KUM & GO GAS & C-STORE

MAJOR SITE DEVELOPMENT PLAN

RECORD DRAWING

2232 - EL PASO, COLORADO
SECURITY BLVD. AND MAIN ST.

STORM SEWER PLAN

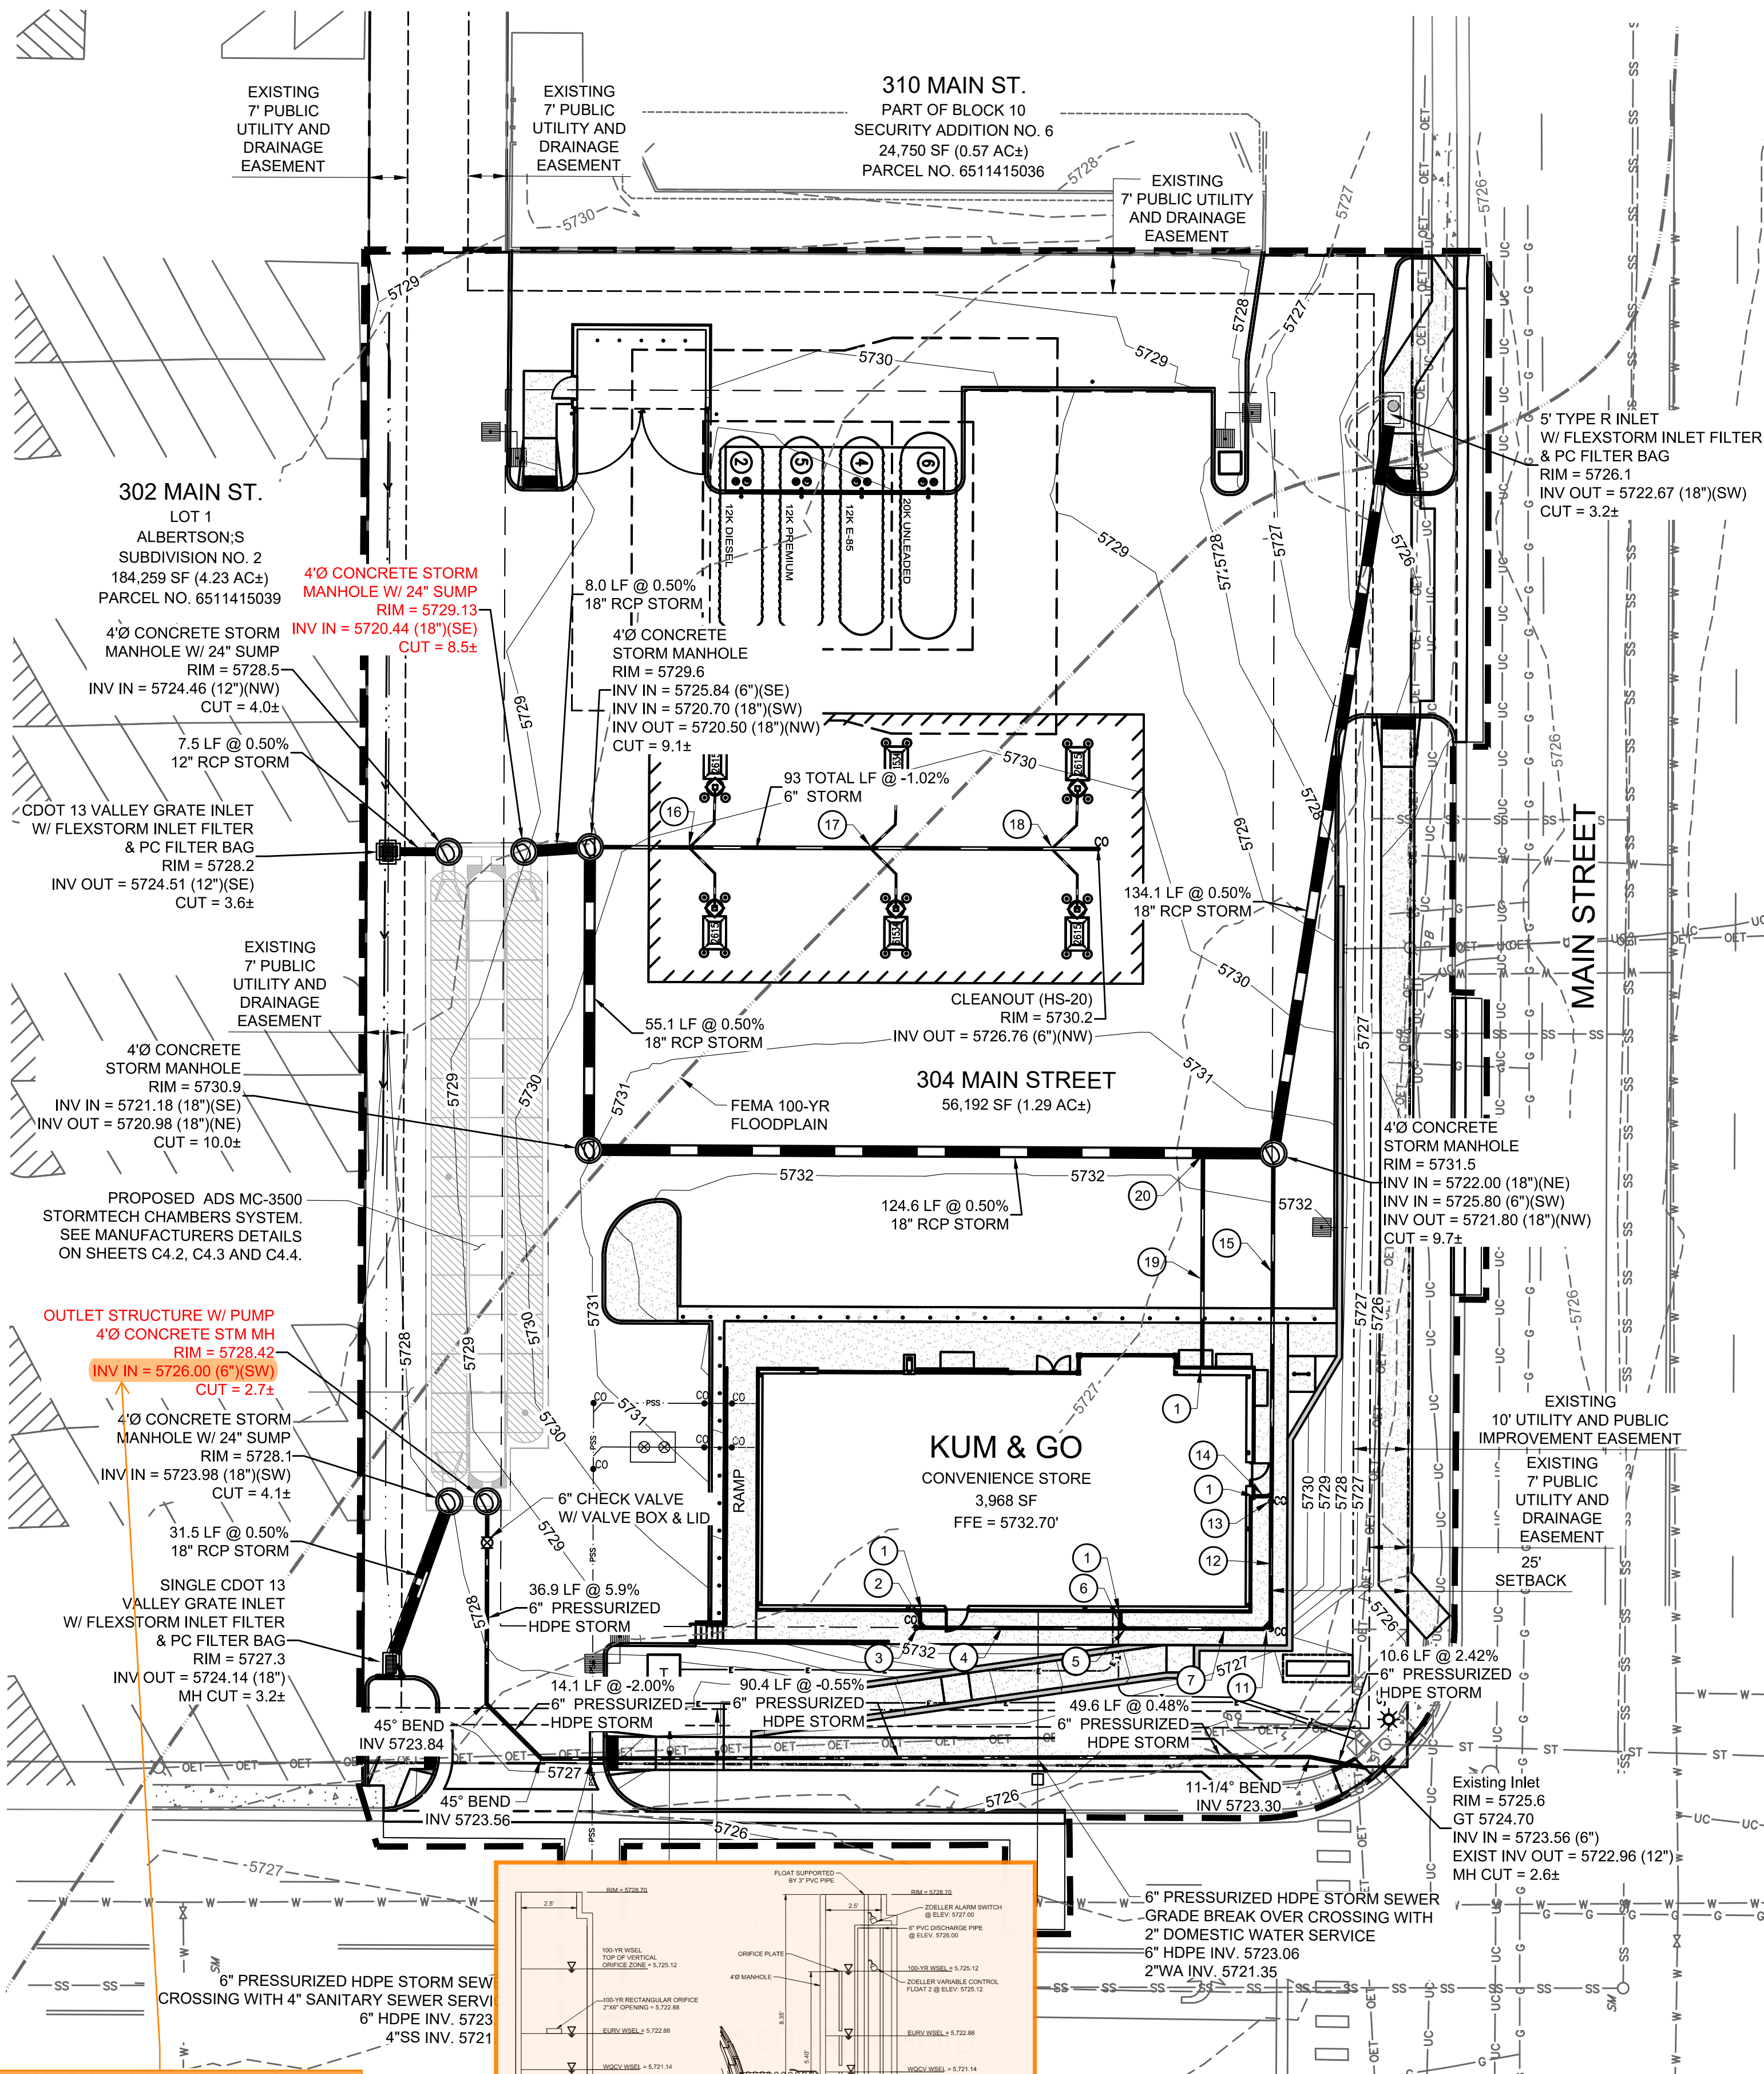
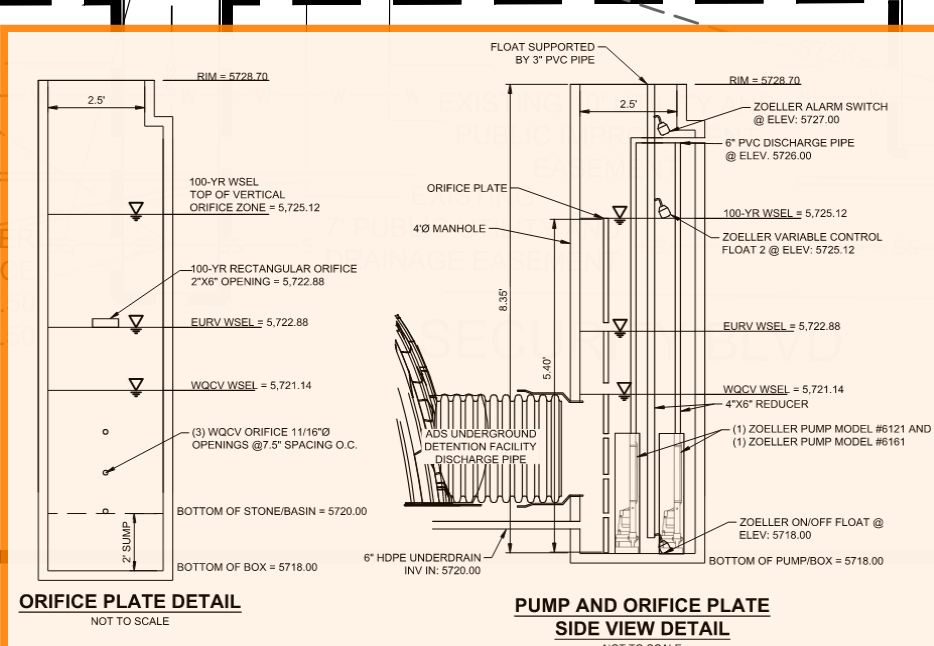
Clarify which 6" pipe this is, as there is a 6" underdrain and a 6" outlet pipe.

Also, please add in and mark-up Sht 24 of 43 that shows the outlet structure, so that you can clearly show where this 6" pipe is (assuming that the surveyors measured the outlet pipe), since the outlet pipe INV isn't labeled on that Sht 24 detail.
